100GBASE-SR4 TDEC & SEC Review Comments r02-36 & r02-37

John Petrilla: Avago Technologies
October 2014

Comment r02-37 Sub-clause 97.7.1, Page 114

Comment r02-36 Sub-clause 97.7.2, Page 115

M in TDEC

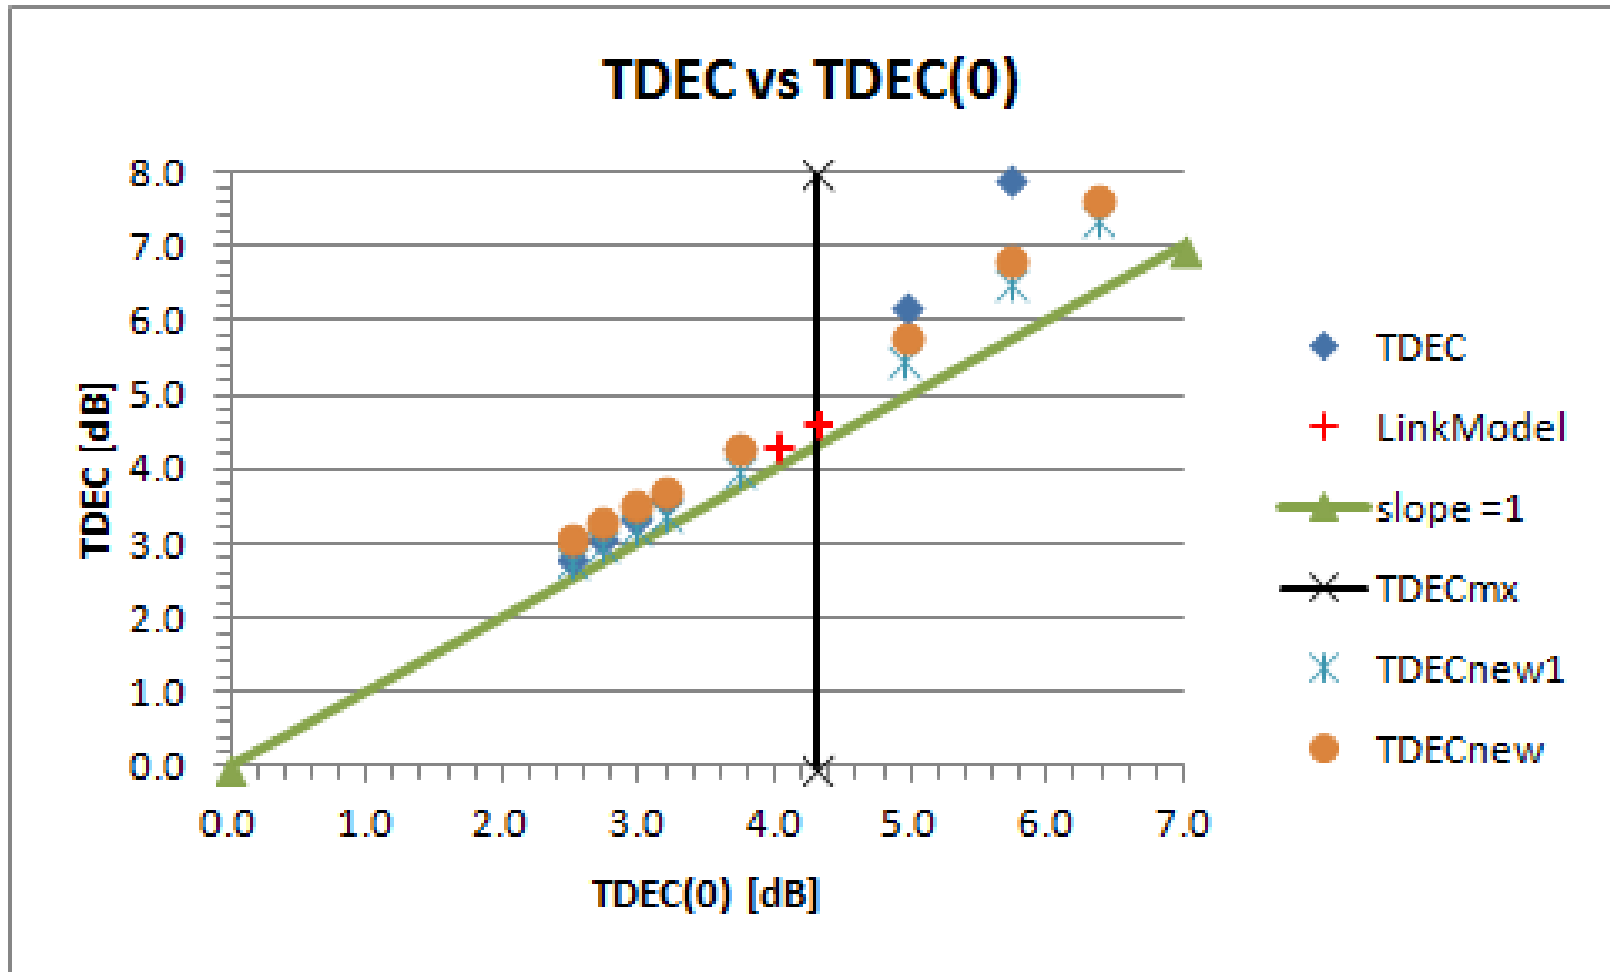
- The chart shows the correlation between TDEC as currently defined and TDEC0 where M is set to zero.
- From the “M in TDEC ...” table on an earlier page, the expected change from the link model due to M set to zero is 0.17 dB, indicated by the + symbols.

- Redefining M such that its effect on TDEC and SEC is reduced by half is recommended.**

SEC & Rx Sensitivity (RxS) Correlations

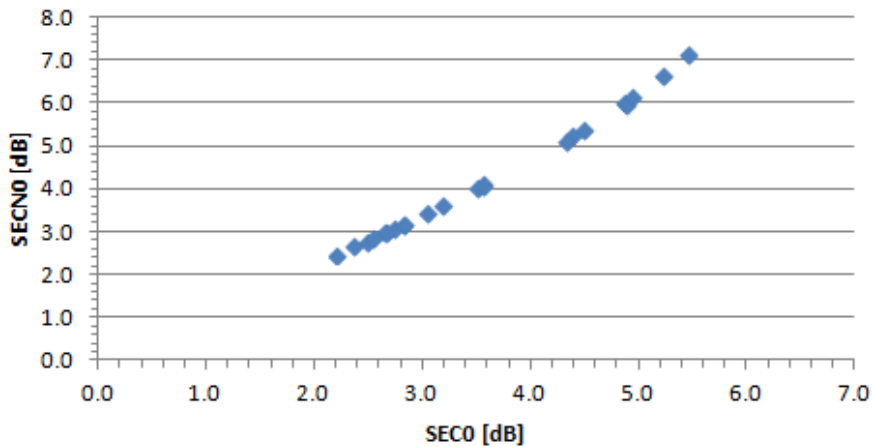
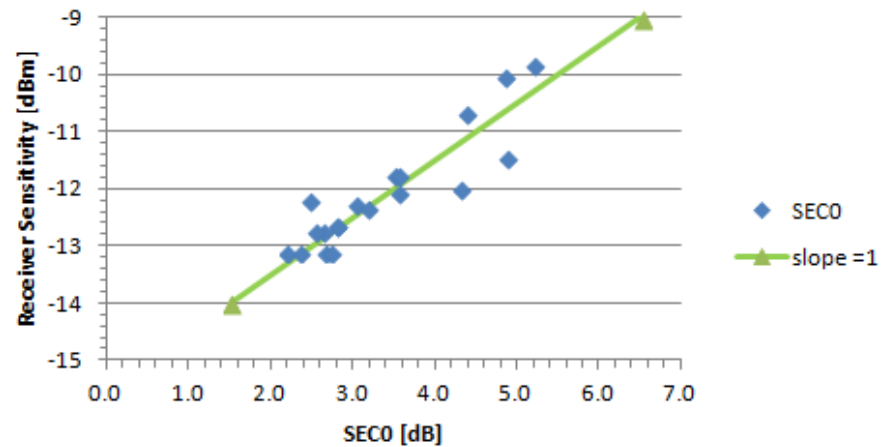
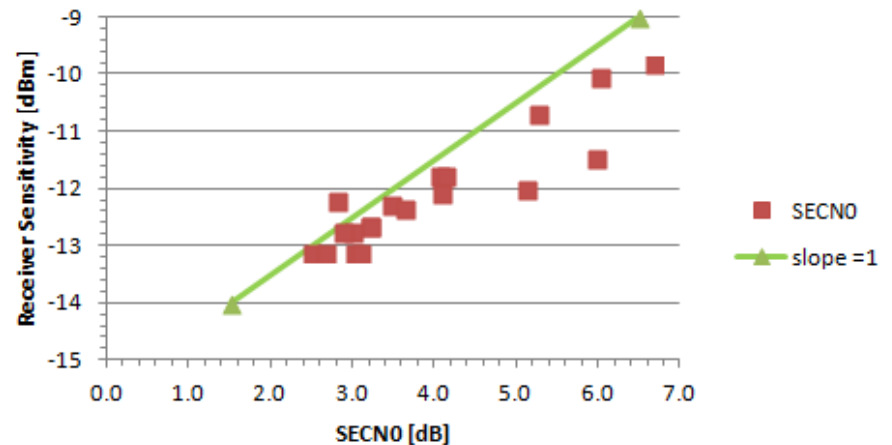
- The top left chart show that the correlation between SEC with M active (SECN0) and M = 0 (SEC0) is very tight and super-linear. The data includes data from 1 m fiber link as well as 150 m fiber links.
- The charts on the left show a more linear correlation between SEC0 (M = 0) and RxS than between SECN0 and RxS.
- It's recommended that the stressed receiver conditions setup continue to use SEC with M = 0 and that stressed receiver sensitivity is adjusted to avoid double inclusion of the stress that M represents.

Receiver Sensitivity, SEC and TDEC Correlations

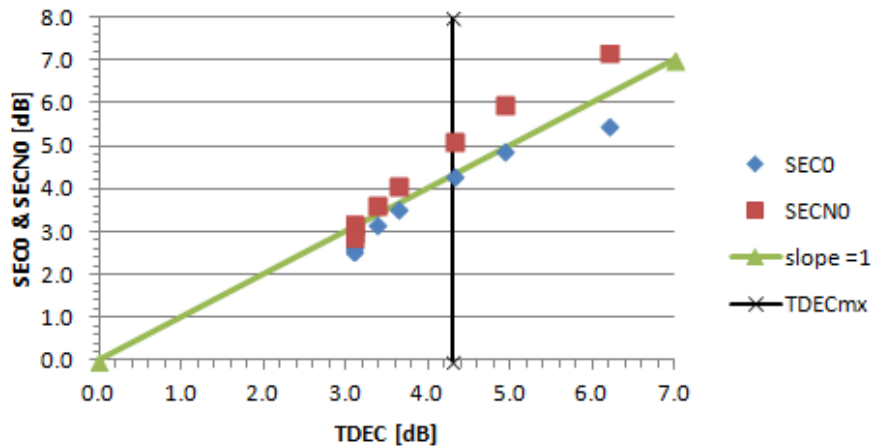
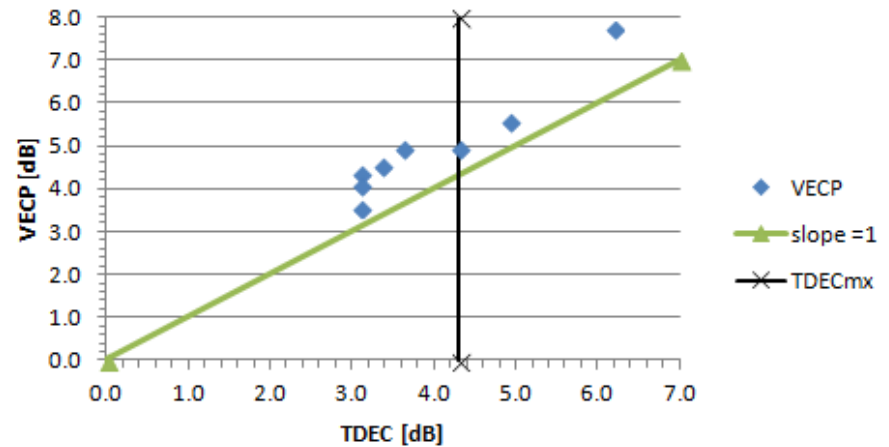
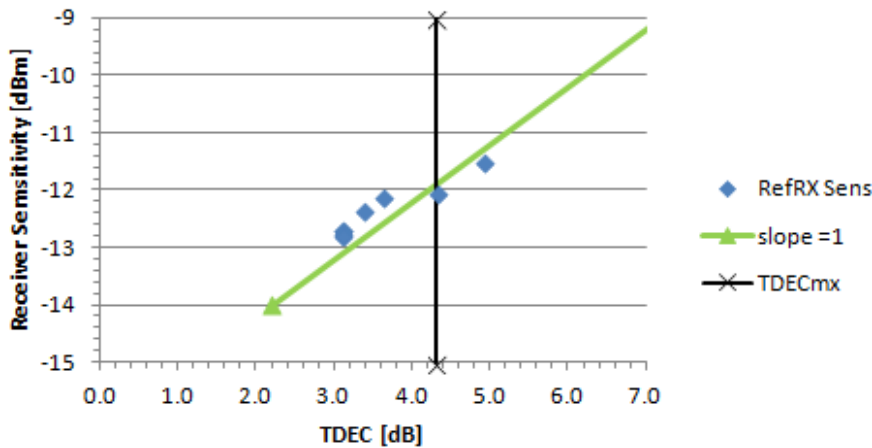
- All the results on the charts on this page are from links with the 150 m OM4 fiber.
- The top left chart shows correlations between TDEC and SECO and SECNO.
- The data indicates that there may be one-to-one correlations between TDEC and SECO, between SECO and RxS and between TDEC and RxS.
- Following the previous recommendation for max TDEC = 4.3 dB a limit line is included on the charts.
- The top right chart shows the correlation between VECP and TDEC results.

•Changing the max TDEC value in Table 95-6 from 4.9 to 4.3 is recommended.

VECP Correlations with SEC0 and TDEC

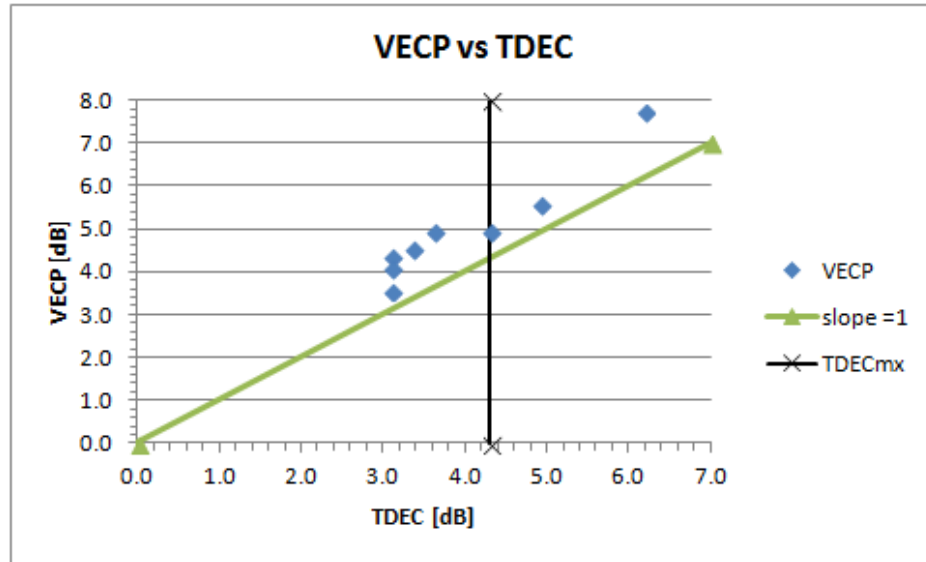
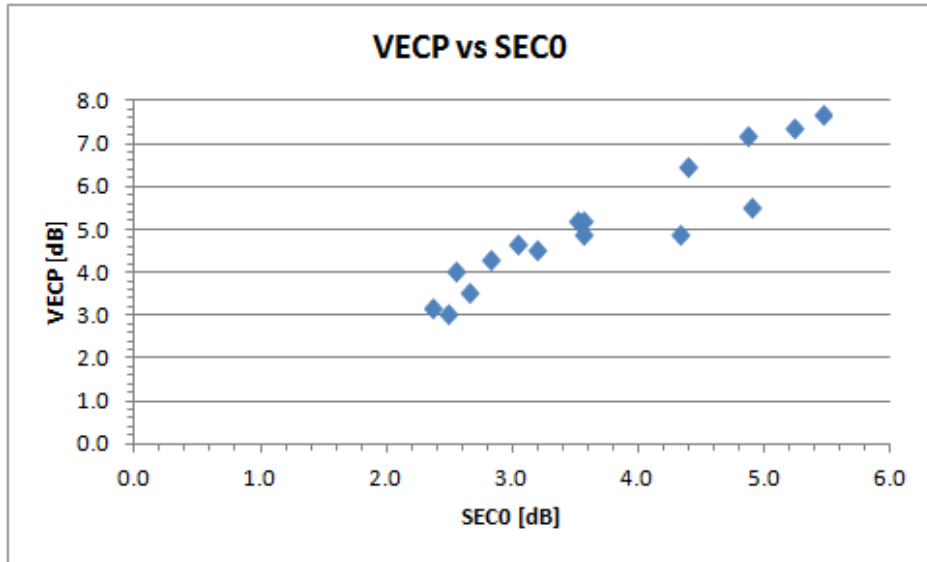
- The top left chart show correlations between VECP and SEC0.
- The top right chart shows the correlation between VECP and TDEC results.

TP3 J2 and J4 (aka Stressed Rx Sensitivity Jitter Conditions)

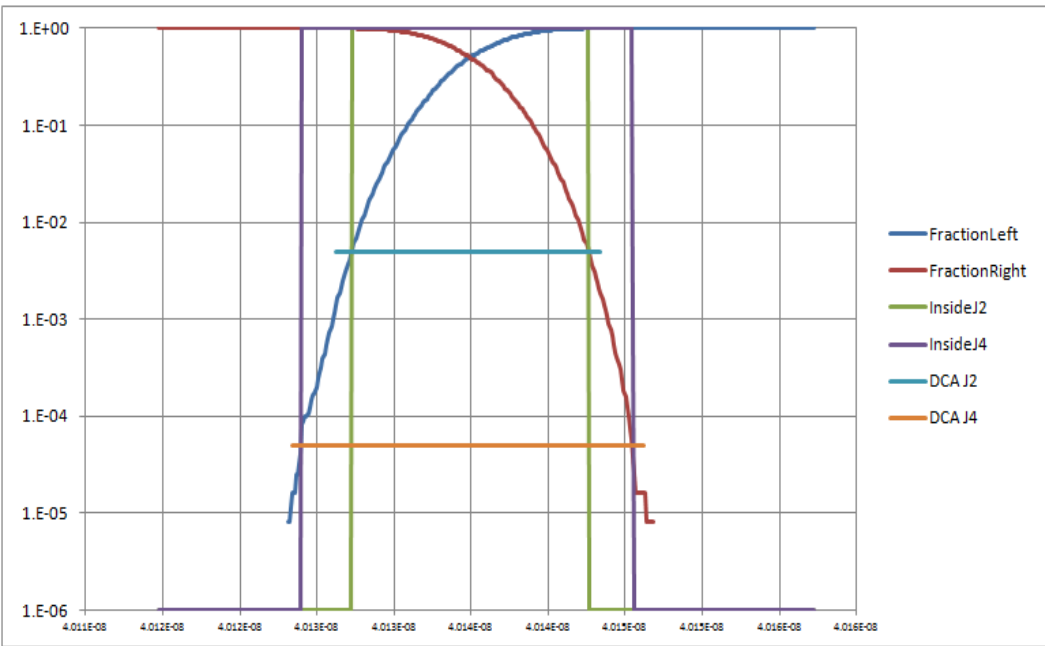
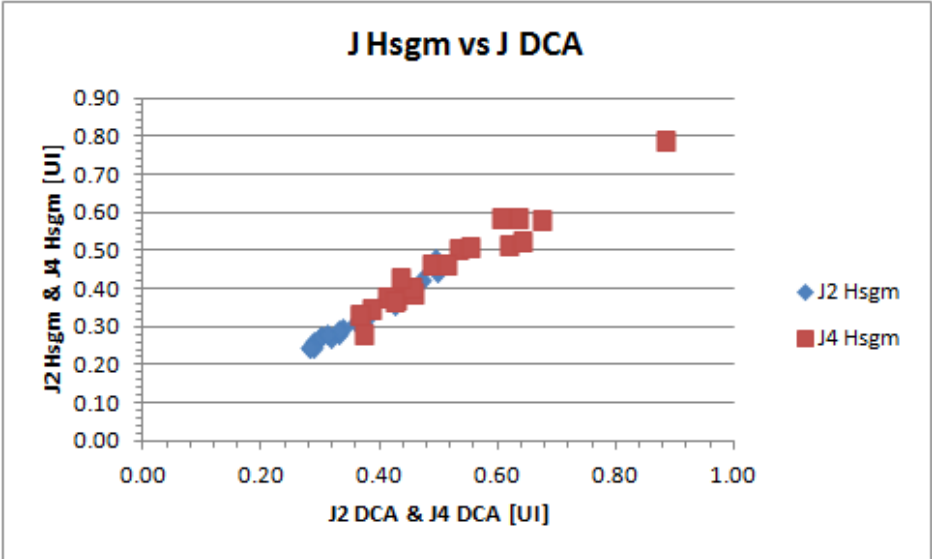
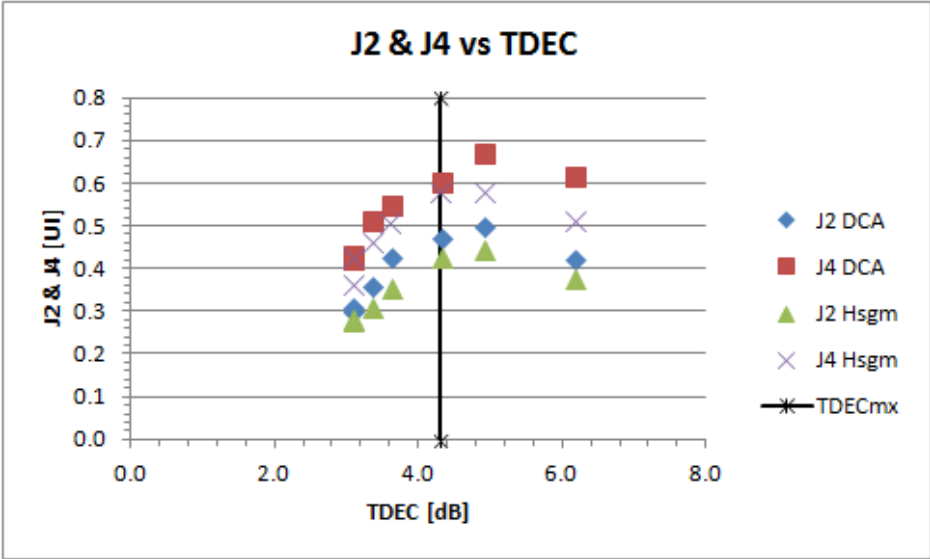
- The top left chart show correlations between J2 & J4 and TDEC for various Tx conditions over the 150 m OM4 fiber link. Where TDEC < 5 dB Tx bias was used to vary TDEC. Where TDEC > 6 dB, a LPF was used to condition the Tx. Differences are seen in jitter values between results reported by the DCA (J DCA) and results (J Hsgm) extracted from the captured histograms.
- The bottom left chart show the histogram extraction method.
- The top right chart shows the correlation between J DCA and JHsgm.

J2 & J4

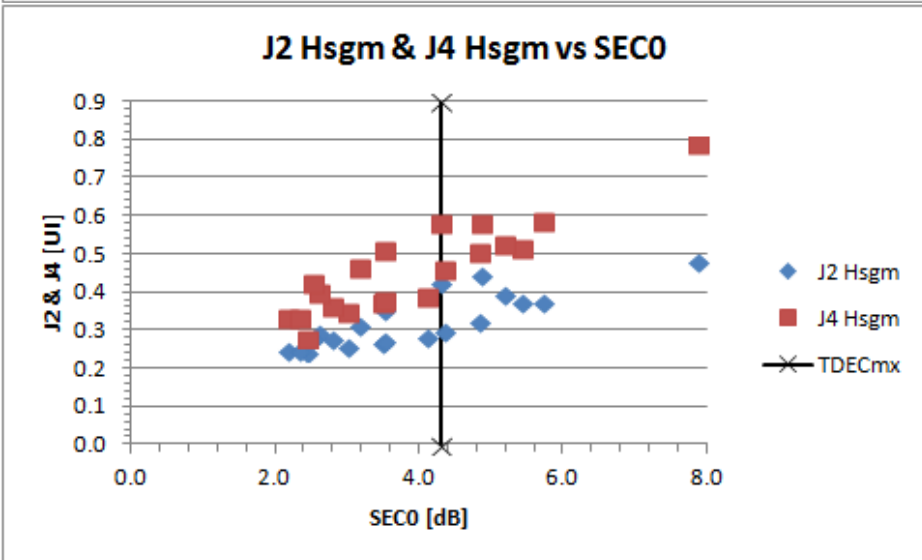
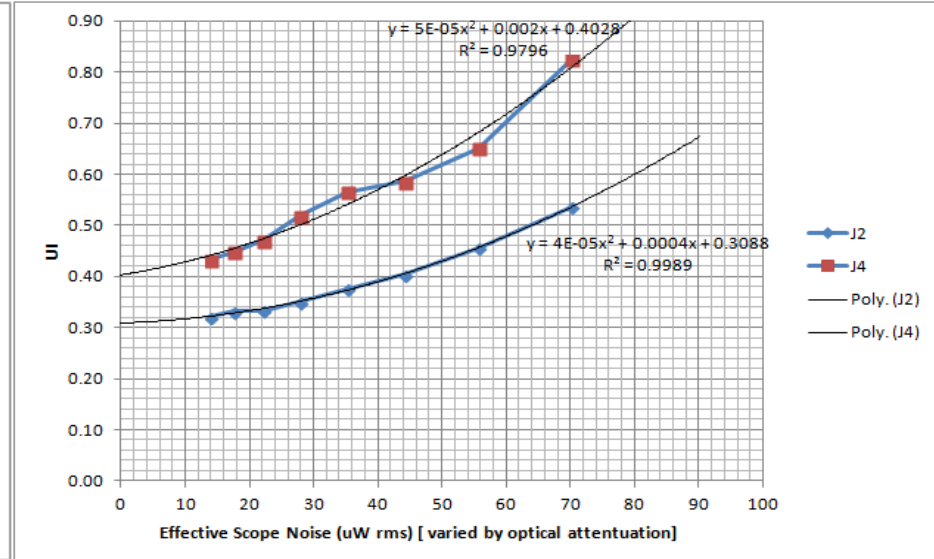
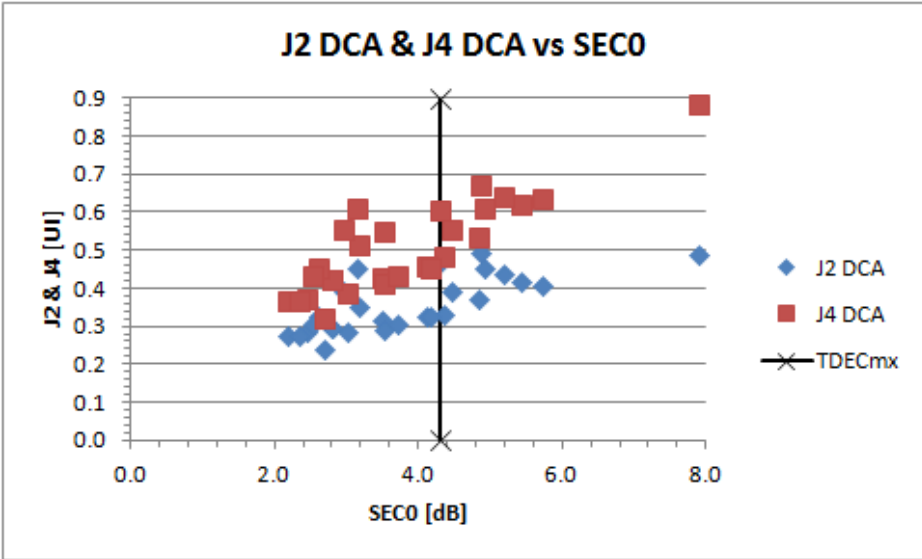
- The charts on the left show the J2 and J4 correlation with SECO. The limit line corresponding with the recommendation for max TDEC = 4.3 dB is included for reference.
- The chart on the right show the effect of scope additive noise on jitter results.
